BP - San Juan Wellwork Procedure P&A

FLORANCE 060R-PC 30-045-23546-00

Attachment to notice of Intention to Abandon:

Well: 60R Florance

Current Wellbore Diagram

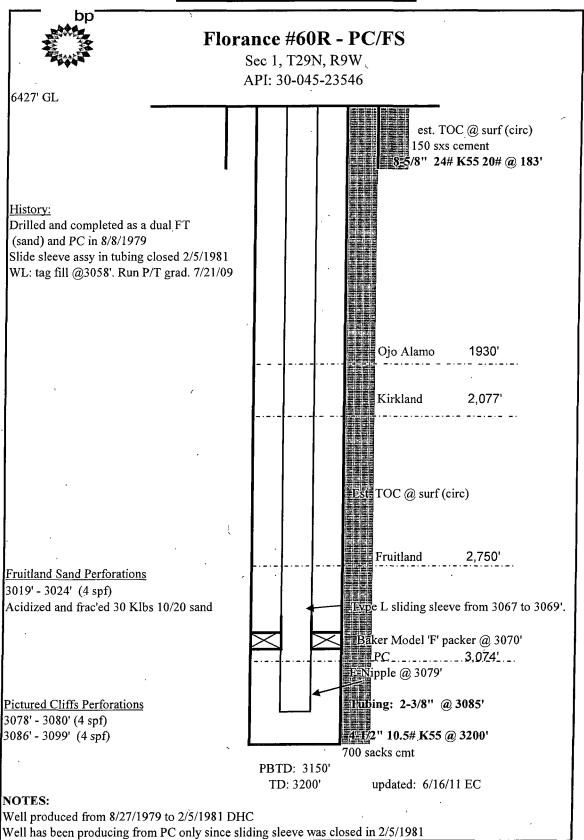
- 1. Plugging operations authorized are subject to the attached "General Requirements for Permanent Abandonment of Wells on Federal and Indian Lease."
- 2. Farmington Office is to be notified at least 24 hours before the plugging operations commence (505) 599-8907.
- 3. The following modifications to your plugging program are to be made:
- a) Place the Kirtland/Ojo Alamo plug from 2127' 1880'.
- b) Place a cement plug from 604' 504' to cover the Nacimiento top.

Place a cement plug from 604'-504' to over the Nacimiento of.
